## Safety Recall Action Notice 579 Issue 3 - 07.2020

Subject: Front Brake Pads			
Bulletin Number	Models Affected	VIN Range	Markets Affected
579	Tiger 1200 XR	From VIN 800262 to VIN AC0327	All Markets Except China
	Tiger 1200 XRx		
	Tiger 1200 XCx		
	Tiger 1200 XRT		
	Tiger 1200 XCA		
	Tiger 1200 XRx (Low Ride Height)		
	Tiger 1200 - Alpine		
	Tiger 1200 - Desert		
	Street Triple RS		
	Speed Triple RS		
	Speed Triple S

### Calipers

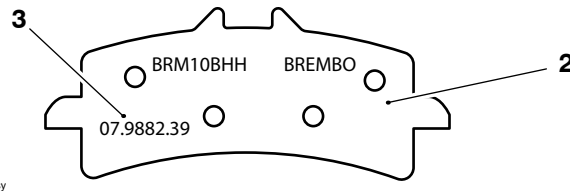
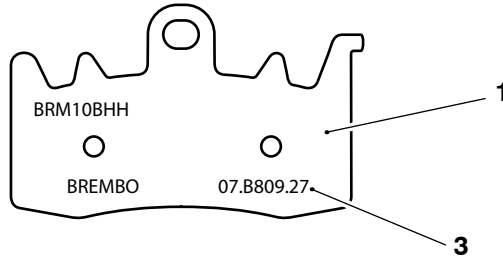
Models	Old (defective) Triumph Brake Caliper Part Numbers	New (remedy) Triumph Brake Caliper Part Numbers
Tiger 1200 models listed above	T2022460 T2022470	T2022970 T2022980
Speed Triple RS and Speed Triple S	T2023530 T2023540	T2023550 T2023560
Street Triple RS	T2021558 T2021559	T2023260 T2023270

1. Tiger 1200 new remedy brake pad
2. Speed Triple and Street Triple new remedy brake pad
3. Brembo part numbers

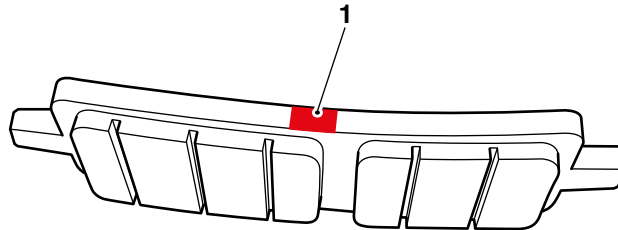
Models	Old (defective) Brembo Brake Pad Part Numbers	New (remedy) Brembo Brake Pad Part Numbers
Tiger 1200 models listed above	07.B809.23	07.B809.27
Speed Triple RS and Speed Triple S	07.9882.36	07.9882.39
Street Triple RS	07.9882.36	07.9882.39

Remedy brake pads include a red paint identifying mark as shown in the following illustration.

1. Red paint identifying mark
